Item Name: Crosstube Turning Detail

DART AEROSPACE LTD	Work Order:	74668
Description: Crosstube Assembly (205/212/412 High Fwd)	Part Number:	D212-664-141
Inspection Dwg: D212-664-141 Rev: D		Page 1 of 1

DRAWING NO. D212-664-141	TITLE XTUBE ASSY (205/212/412 HI FWD)	REV. D	DART AEROSPACE LTD ENGINEERING ORDER		D.E.O. NO. D212-664-141-D-1	SHEET NO. SHEET 1 OF 2	SCALE NTS
DRAWN	CHECKED	MFG. APPR.	APPROVED	DE APPR.			
DATE 11.04.07	DATE 11.07.11	DATE 11.04.12	DATE 11/04/12	DATE 11.04.12

ADD AN INSPECTION WINDOW TO UNDERSIDE OF CROSSTUBE.

D212-664-141/-141B
ASSEMBLY DETAIL

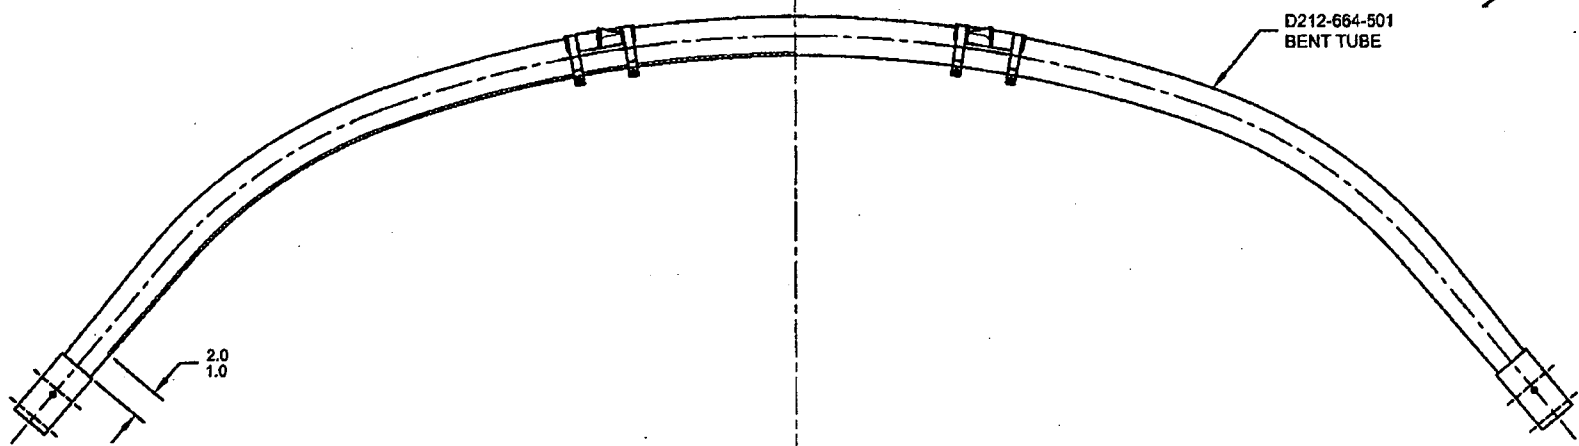
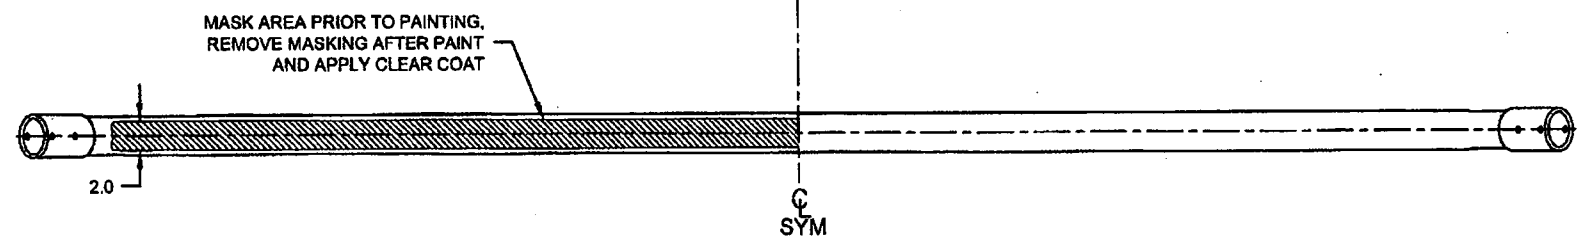
NOTES 2 OF SHEET 1 IS AMENDED AS FOLLOWS:

- 2) FINISH: CHEMICAL CONVERSION COAT PER DART QSI 005 4.1
PRIME INSIDE AND OUTSIDE PER DART QSI 005 4.2
MASK UNDERSIDE OF CROSSTUBE AS SHOWN (HATCHED AREA) AND
PAINT OUTSIDE PER DART QSI 005 4.2
REMOVE MASKING AND APPLY CLEAR COAT
